REGULATORY INFORMATION DISTRIBUTION SYSTEM (RIDS)

SUBJECT: Provides description of mod re switchyard degraded voltage issue, per 900426 conference call.

Subject: Oconee Nuclear Station
Docket Nos. 50-269, -270, -287
Switchyard Degraded Voltage

Oconee Nuclear Station
Preliminary Logic Diagram
230KV Switchyard Degraded Voltage Protection
NSM ON-52850
May 4, 1990

new undervoltage relays

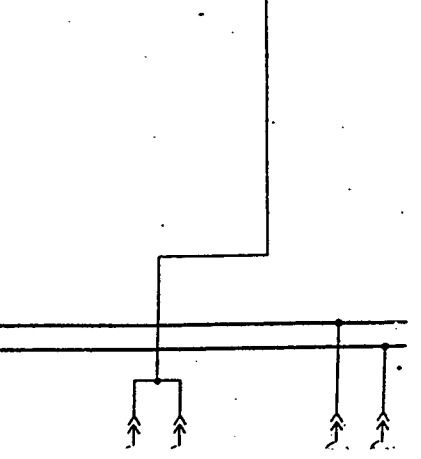
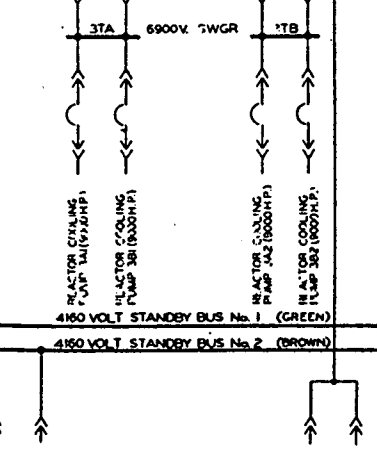
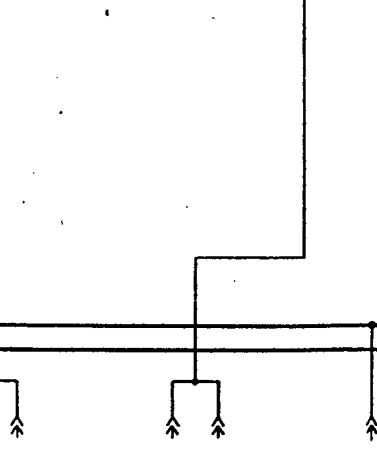
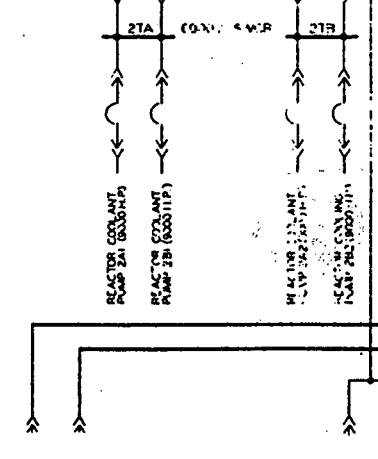
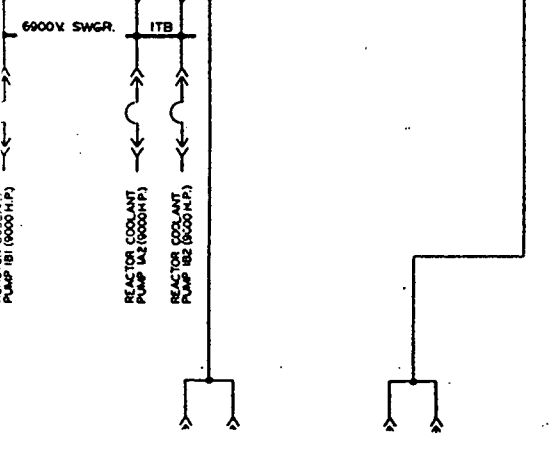
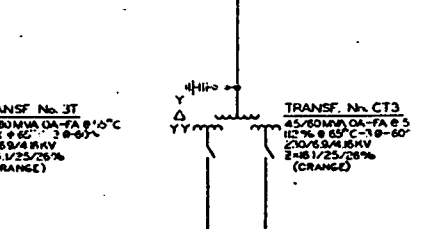
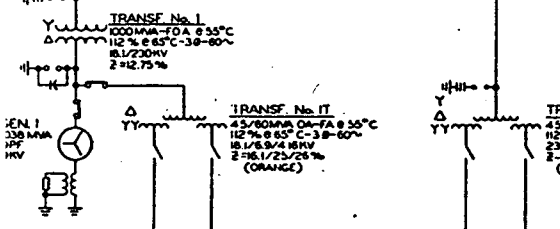
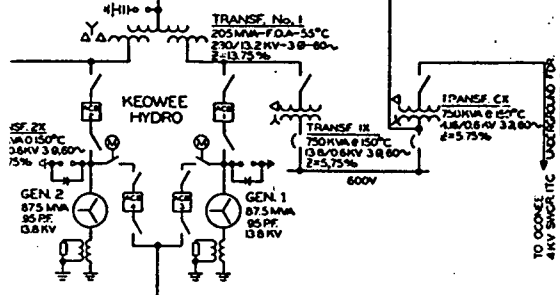
As I stated earlier, to resolve the problems identified, a modification to the plant was proposed. This modification is to install three undervoltage relays to monitor the switchyard voltage on the line side of each of the three startup transformers. Each of the undervoltage relays will be connected to one of three existing single phase spare potential transformers. These relays will be connected in a two out three configuration and timed to provide a permissive in each of the two redundant switchyard isolate circuits through one of two redundant Cutler Hammer relays. This logic will provide inputs for alarms via the Operator Aid Computer, the Event Recorder, an annunciator in the unit 1 and 2 control room, an alarm in the Power System Control Area Operation Center, and would initiate switchyard isolate if an ES signal is present on any of the three units. This logic which is safety related, will be fed from the switchyard 125VDC system.

The modification will install equipment that will provide an annunciator alarm in the Unit 1 and 2 control room, an alarm via the unit Operator Aid Computer an alarm to the Power Systems Control Area Operation Center and an event recorder point and, if an ES signal occurs on any unit while the voltage is at or below the setpoint, will automatically isolate the switchyard by initiating the External Grid Trouble Protection (EGTPS) system. The new logic will ensure the overhead power path from Keowee is available during an ES event, even if the switchyard voltage is below 219KV. The modification will install several relays to accomplish this logic.

The voltage will be measured by existing potential transformers (PTs). The failure modes of these PTs are in the safe direction. The safety related voltage relay contacts used in the switchyard isolation logic will be arranged in a 2 out of 3 (2/3) logic. The output of the 2/3 logic will be connected to actuate two redundant safety related relays. If this 2/3 logic is satisfied and an ES signal occurs on any of the three units, both channels of the EGTPS will be activated. If the EGTPS is actuated by a failure of this new logic, unit generation would not be interrupted since the EGTPS does not operate the unit tie breakers.

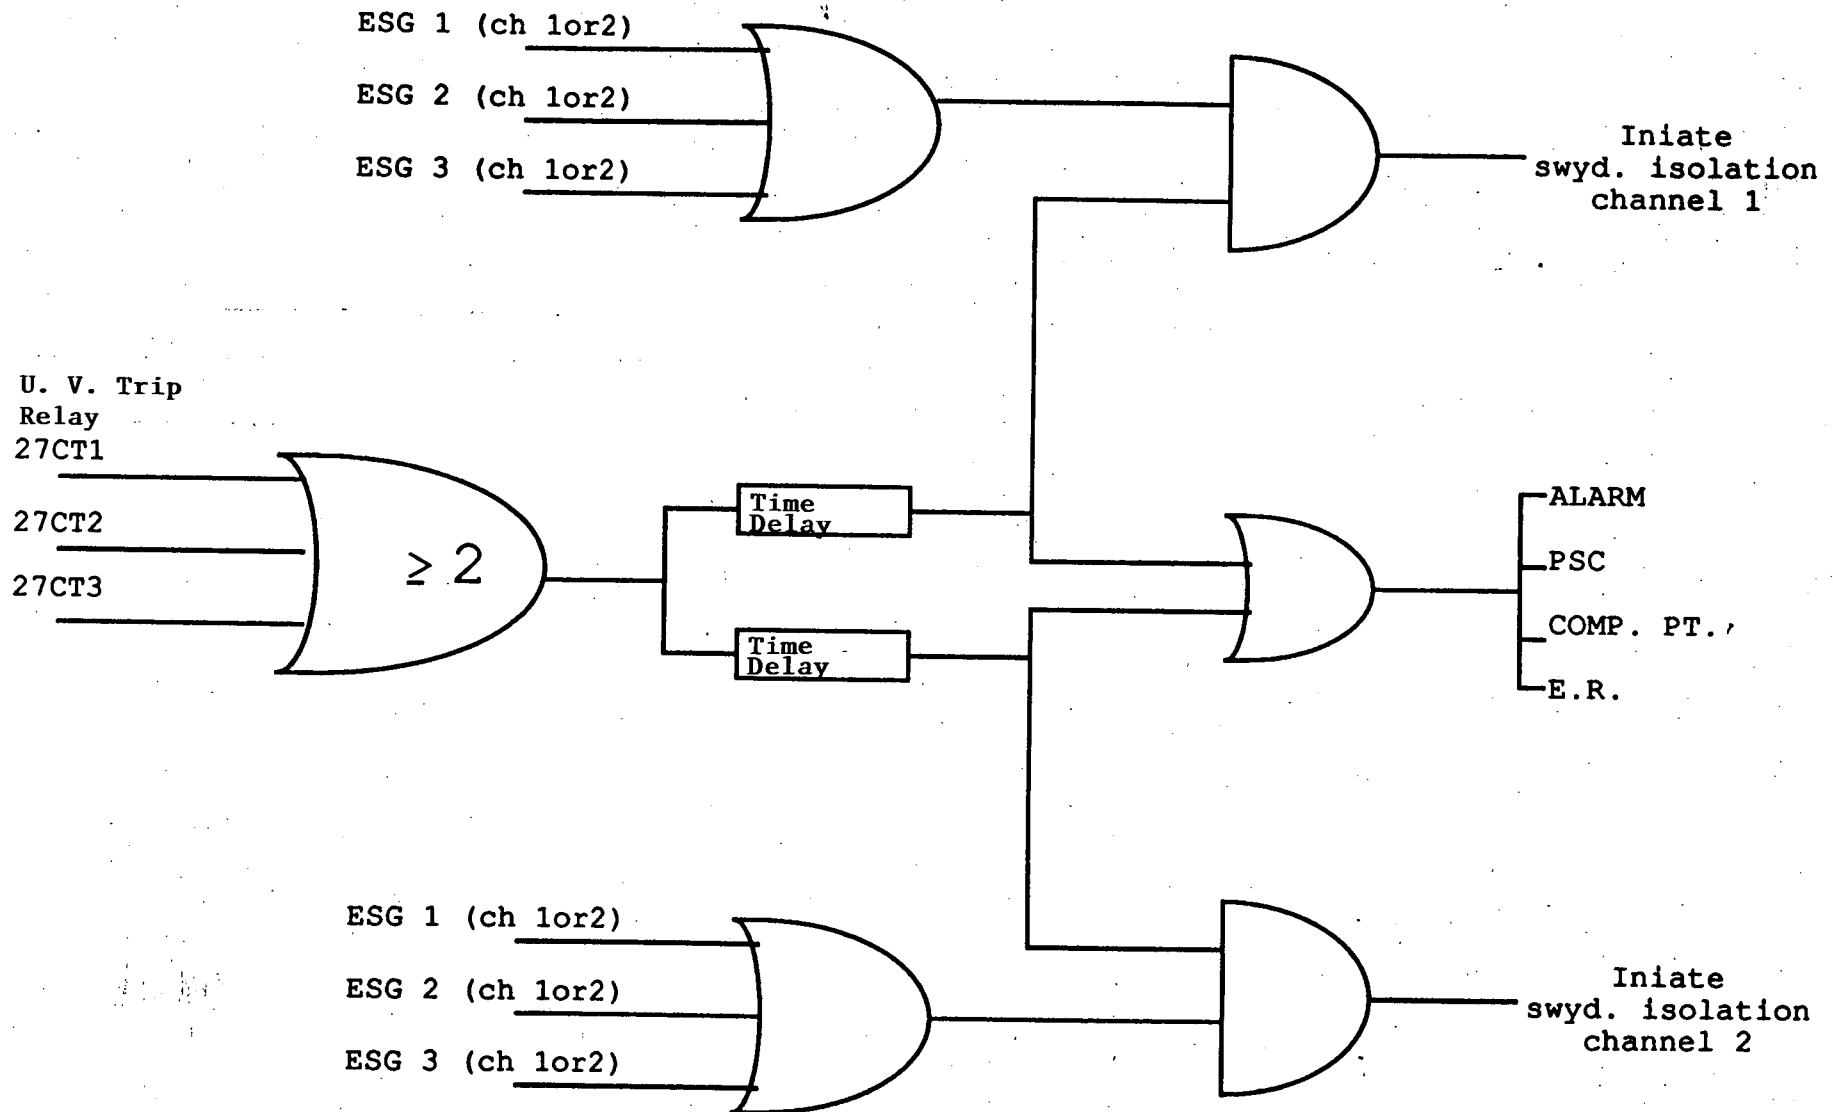
The Engineered Safeguards Protective System (ESPS) is a three channel redundant system employing 2/3 coincidence between measured variables. The ESPS consists of eight 2/3 coincidence logic networks for actuating the equipment in four safeguards systems, thus each system is actuated by a pair of 2/3 logic. Therefore a failure within one channel of the ESPS will not result in an ES signal being provided to the 230KV Switchyard Degraded Voltage Protection Circuitry (230KV SDVP). Further details regarding the ESPS at Oconee is provided by section 7.3.2 of the Oconee FSAR. An inadvertent EGTPS actuation would allow the units to continue to operate safely, since the generator output breakers would remain aligned to the system grid through the 230KV Switchyard red bus (units 1 and 2) or 525KV Switchyard (unit 3). In this condition, the units' auxiliary electrical power would continue to be supplied from auxiliary transformer 1T, 2T, or 3T, respectively. An EGTPS actuation due to degraded grid voltage and a concurrent ESPS signal would allow the unaffected units to continue to operate in the manner just described, while power to the affected unit would be automatically available through:
